## Avon Parks – Burnett Park and Winton Meadows Park Addendum 02

DATE: Friday, February 20, 2026

PROJECT NAME: **Burnette Park and Winton Meadows Park**

The extent of this addendum is as follows:

**STORM SEWER PLAN & PROFILES**

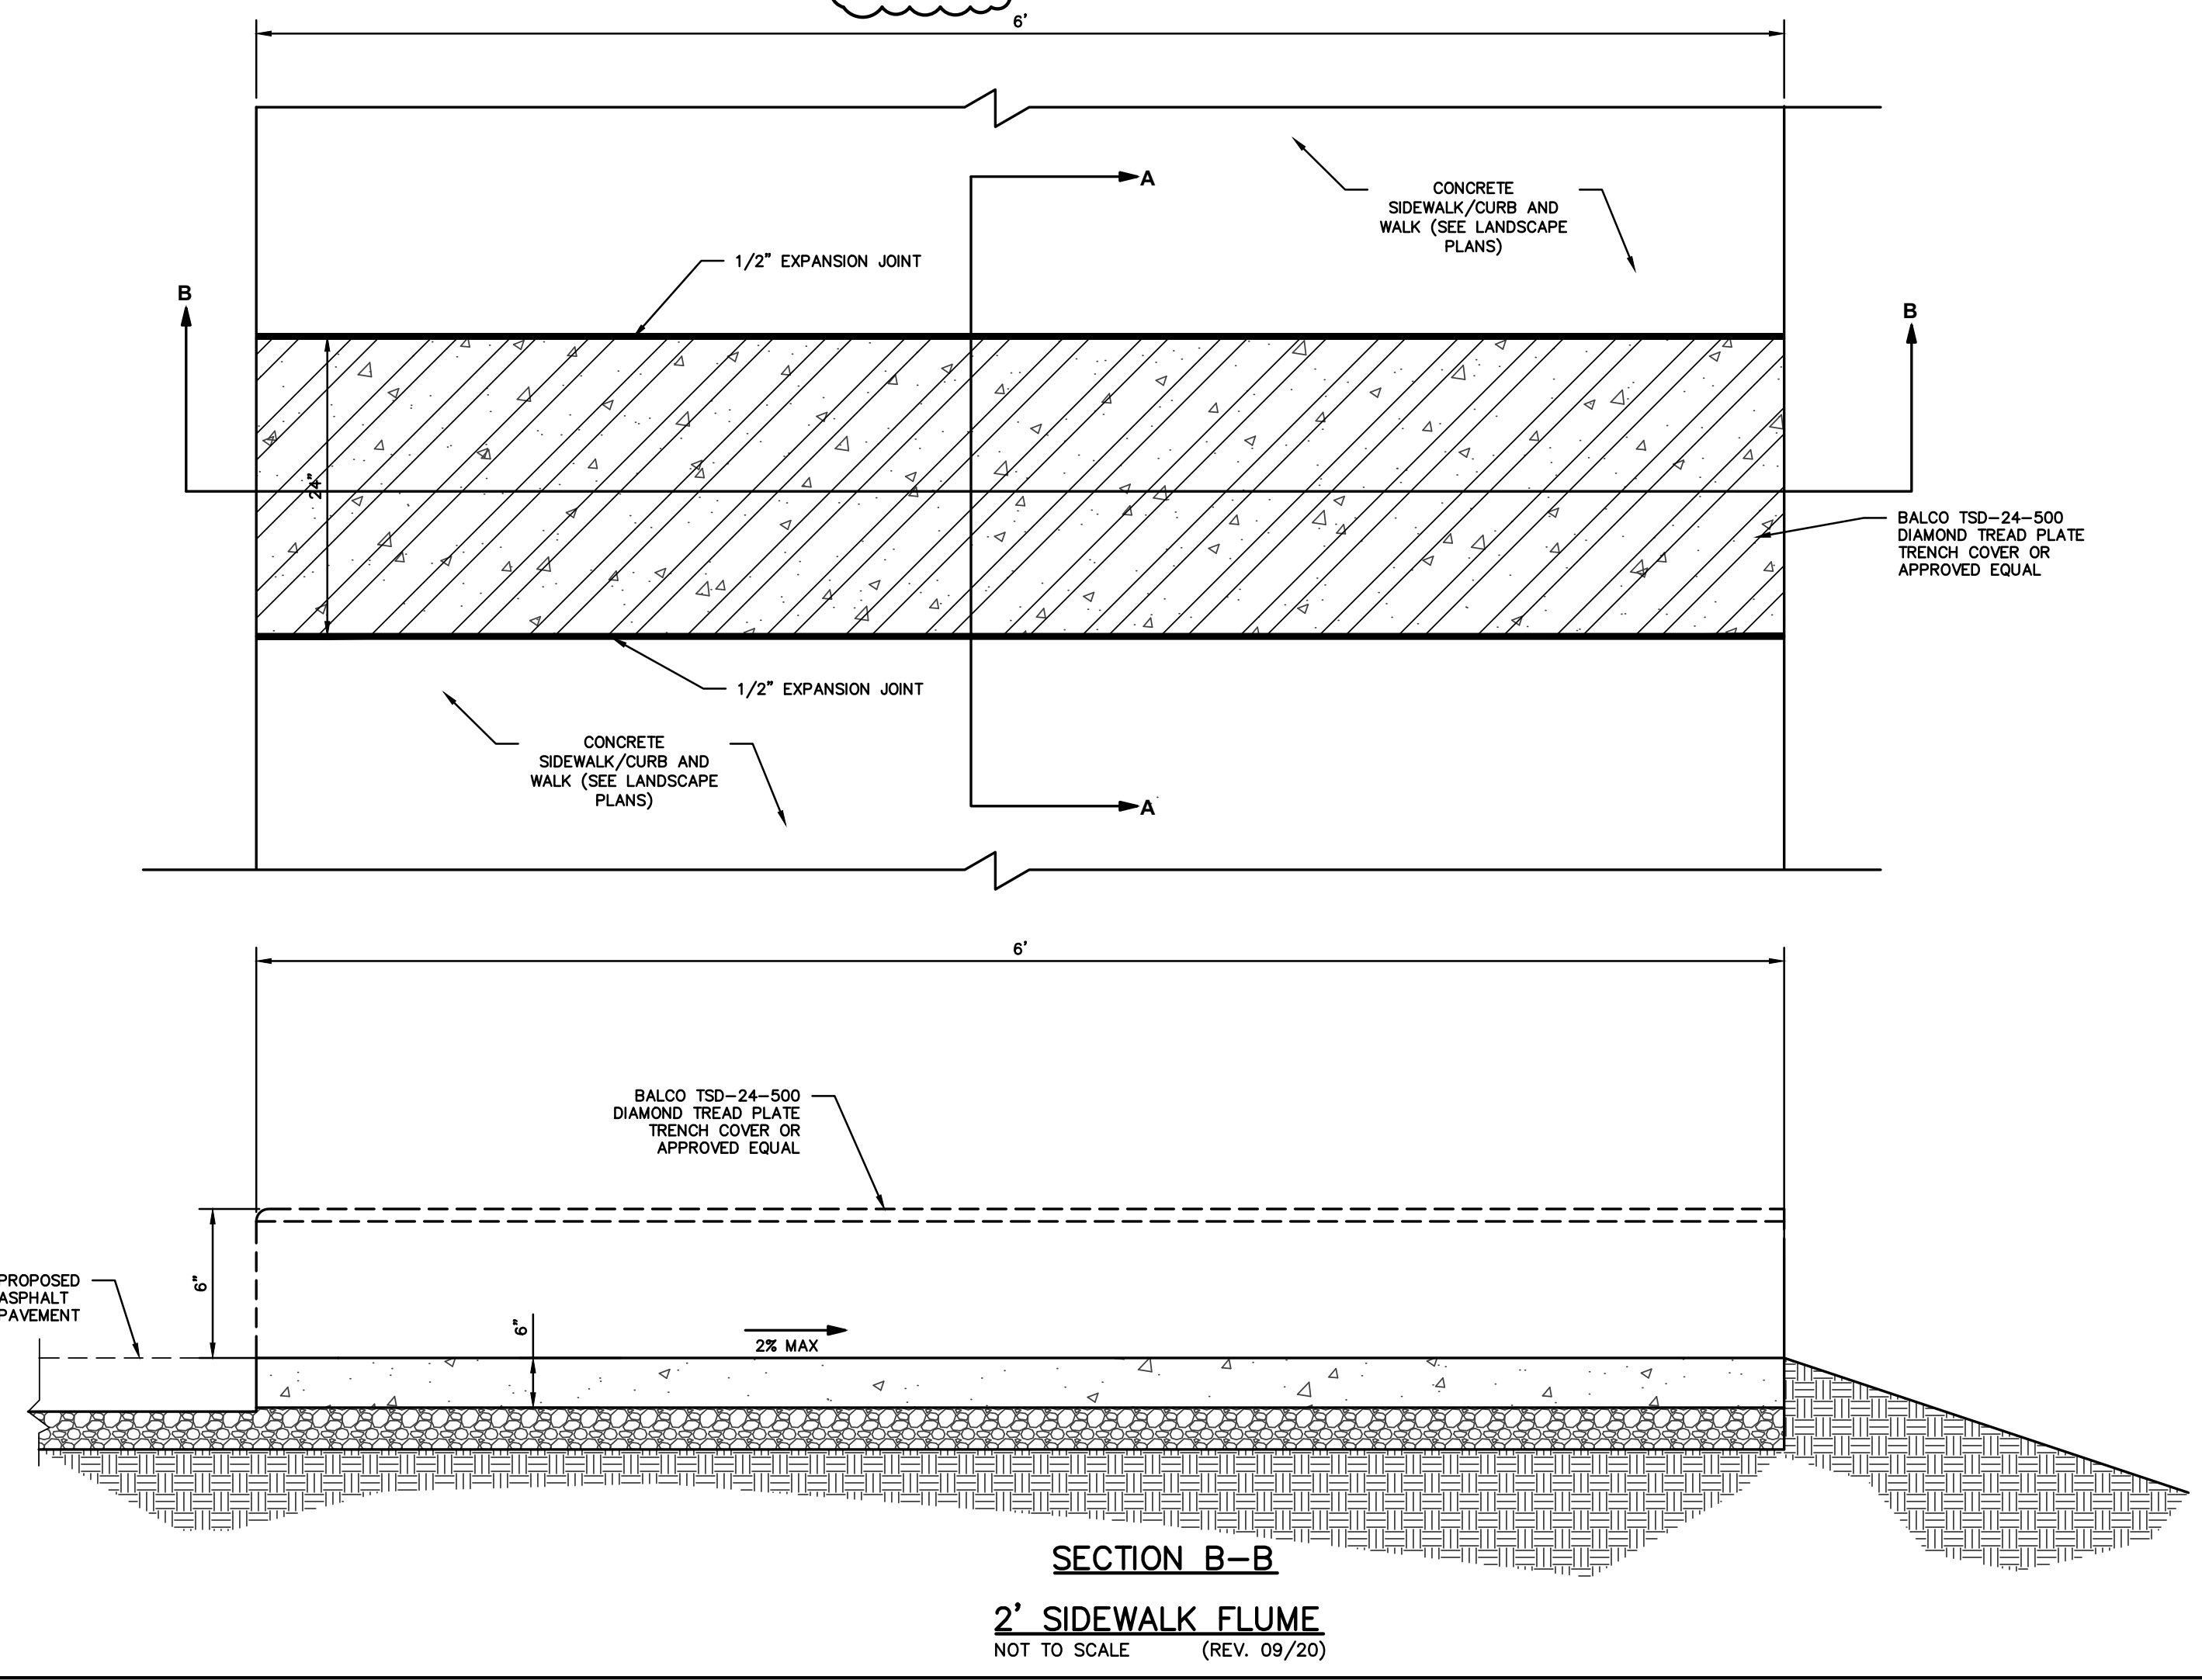
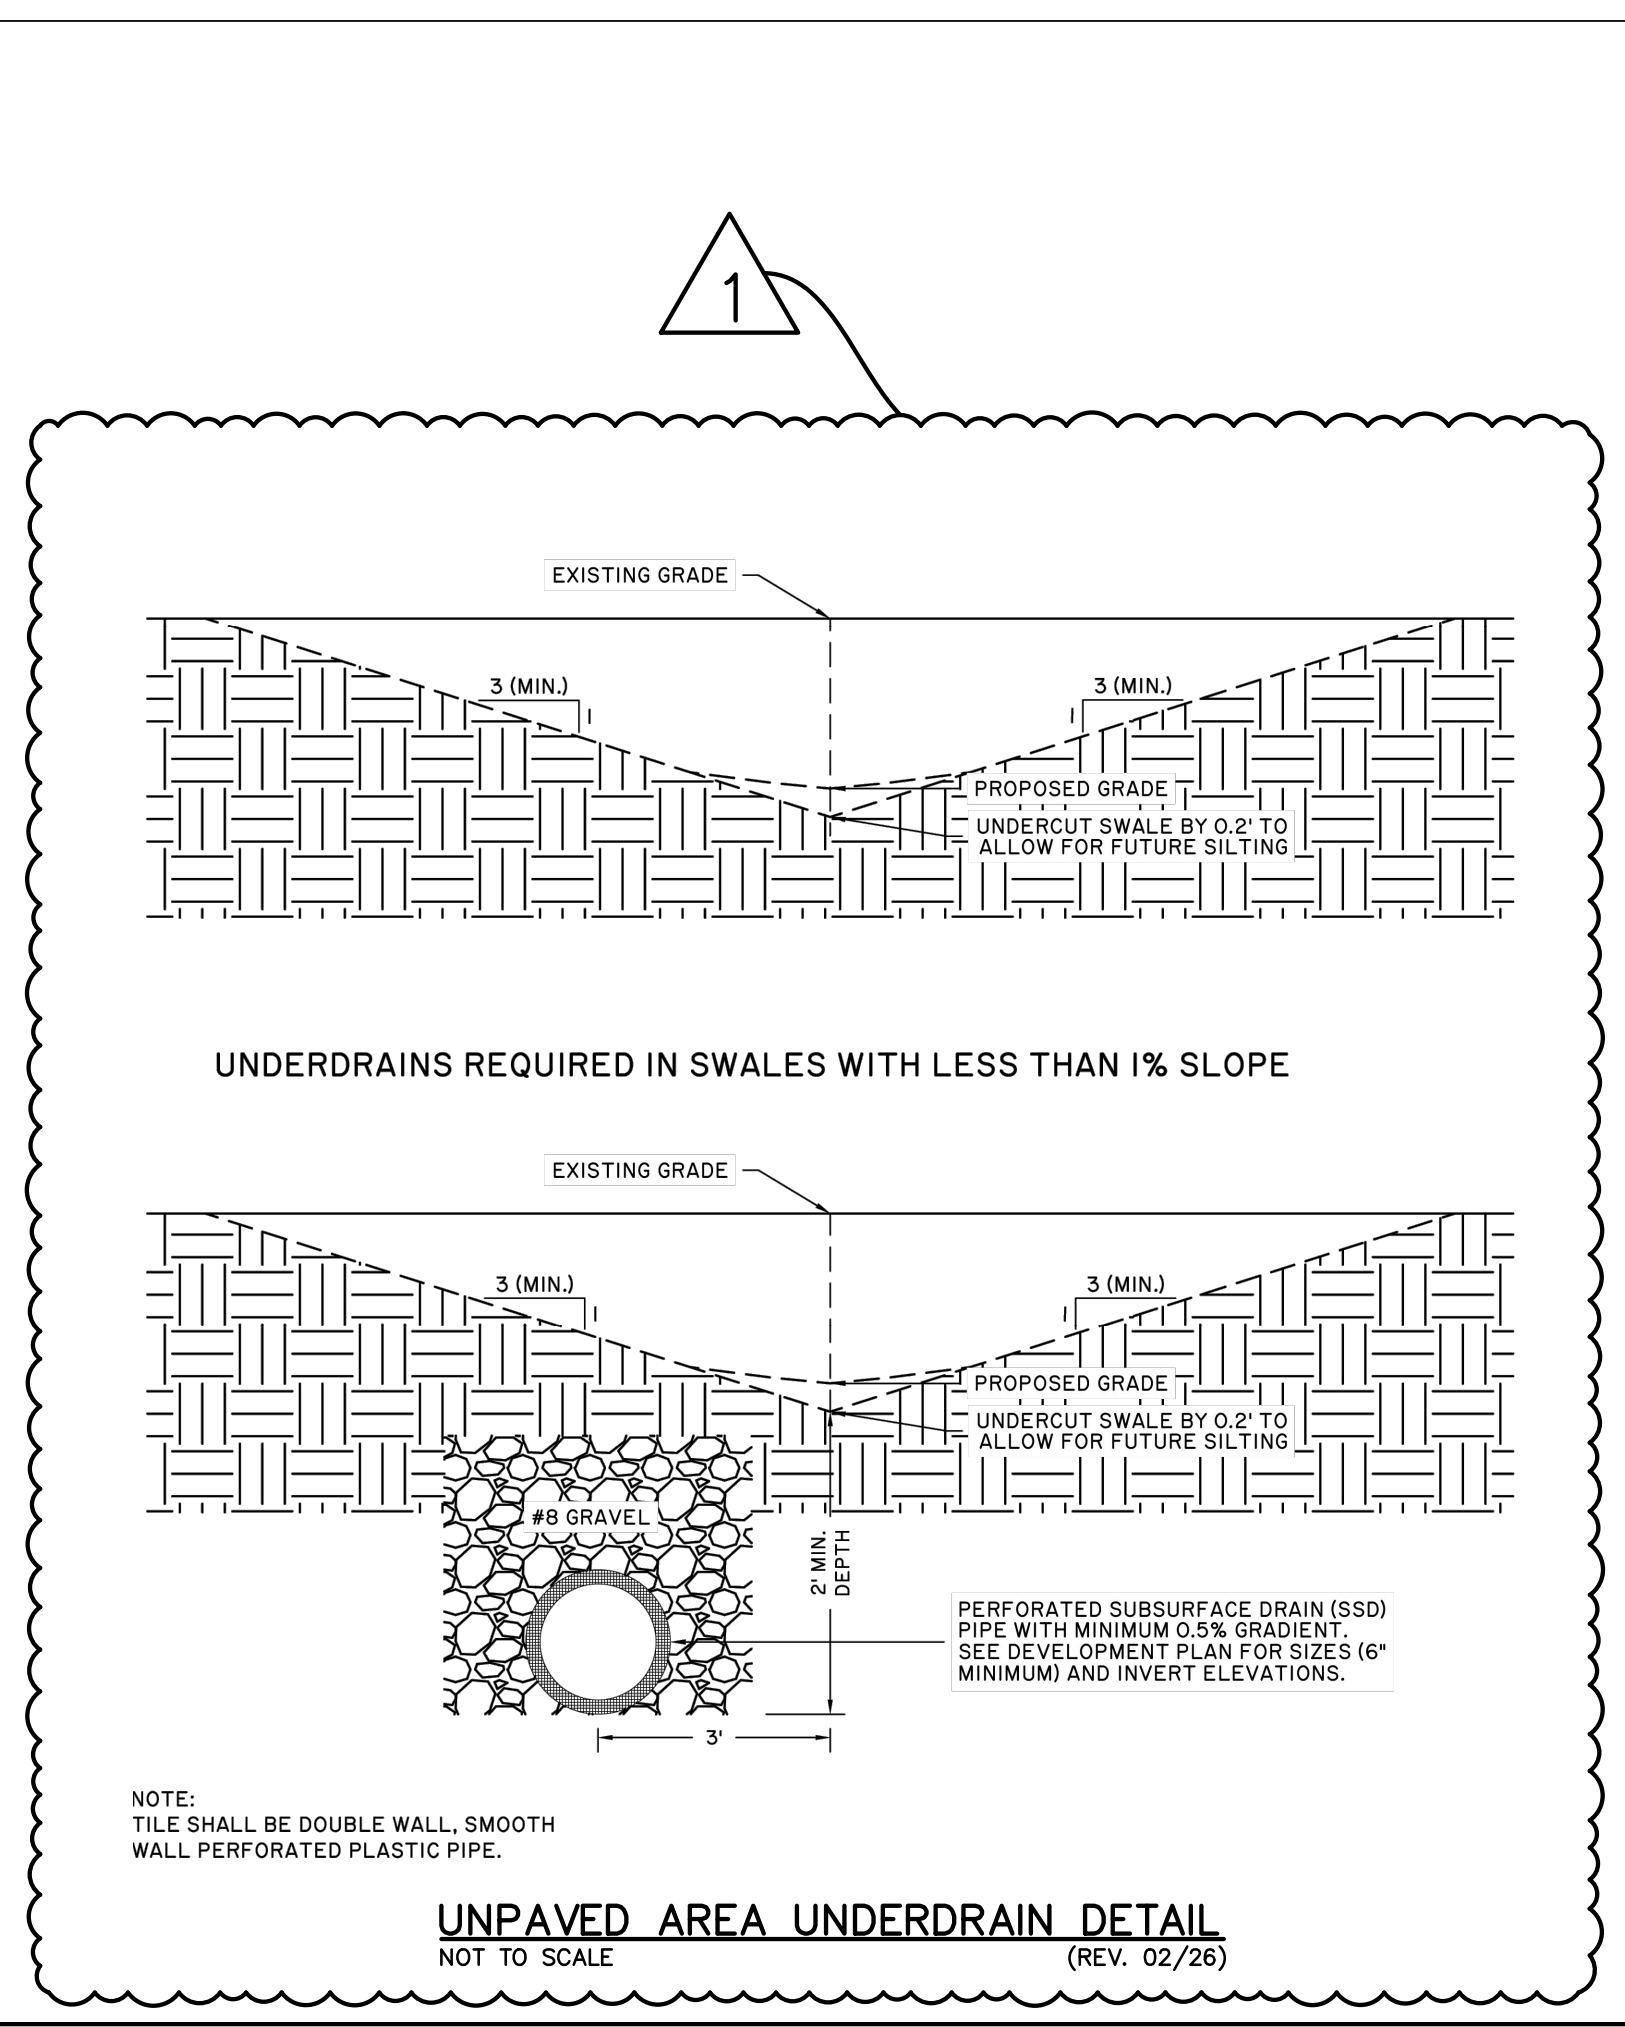
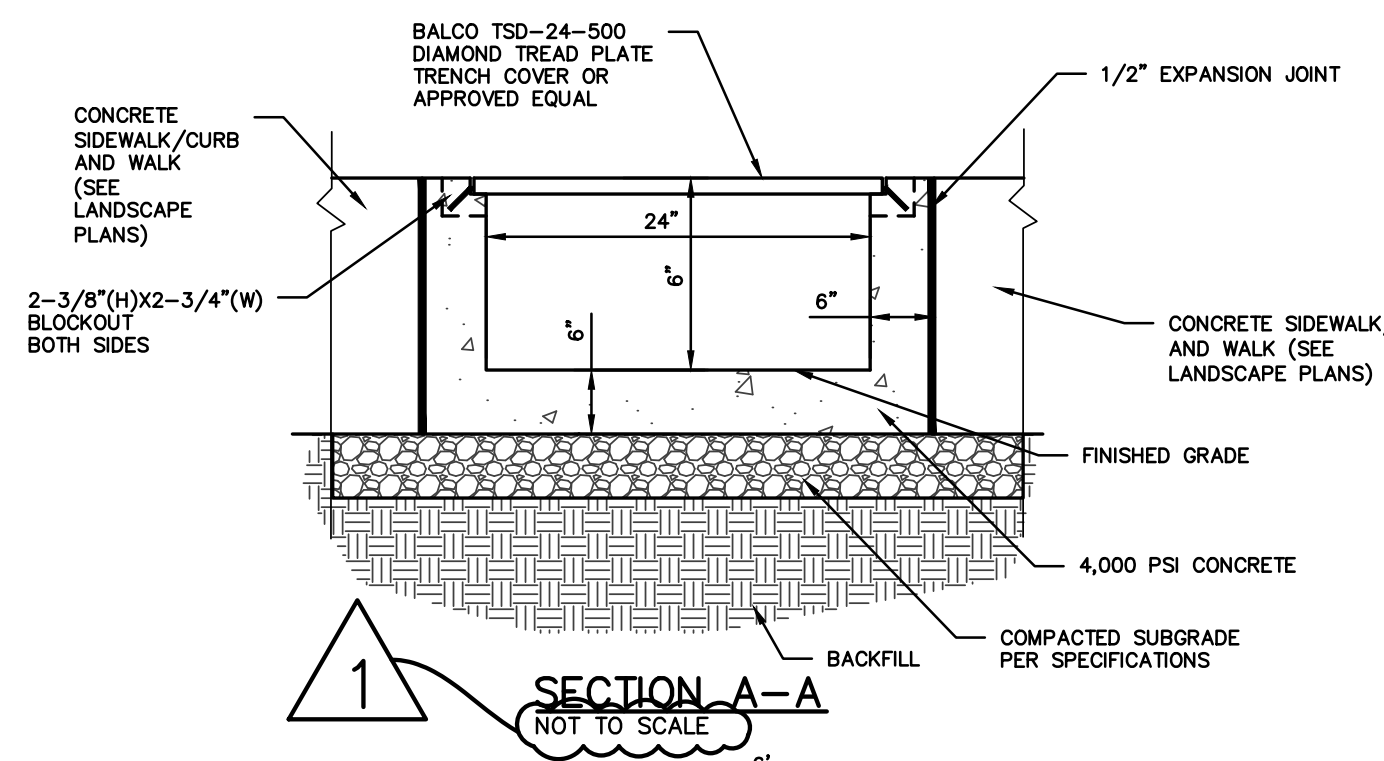
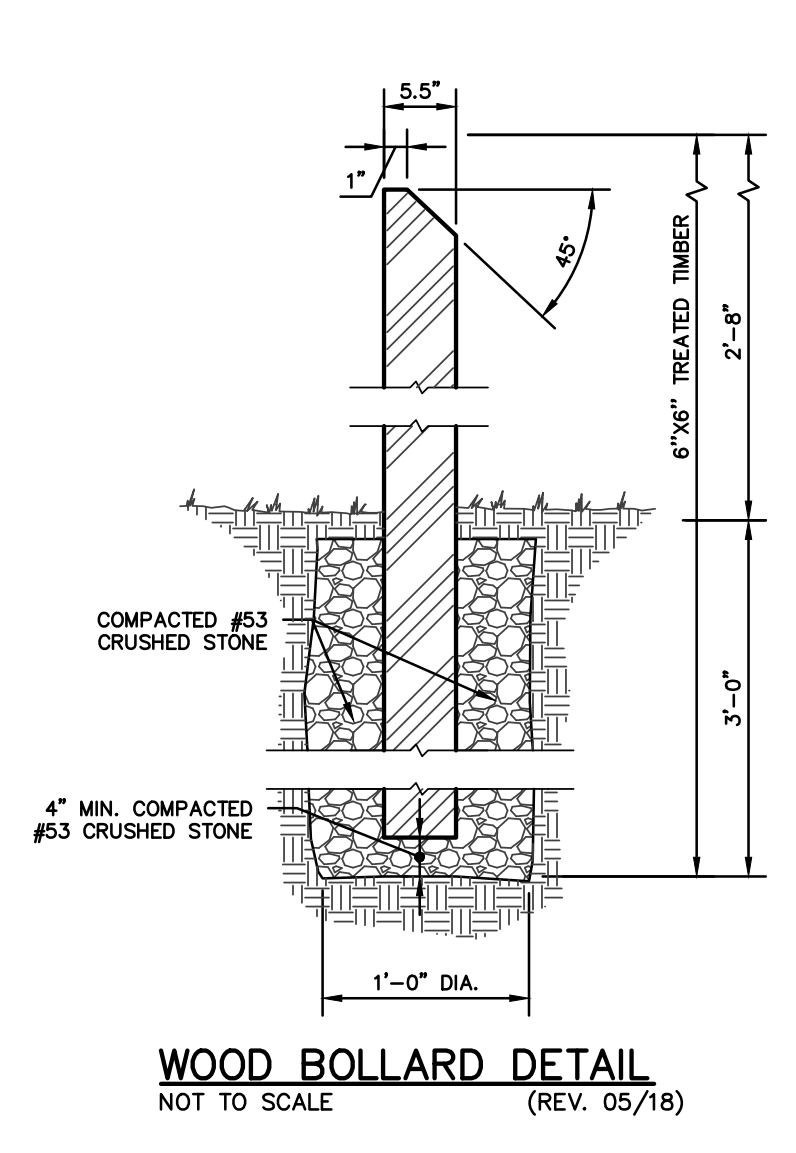
- a) STR 101 revised to inlet. Granular backfill shown from 101-102.
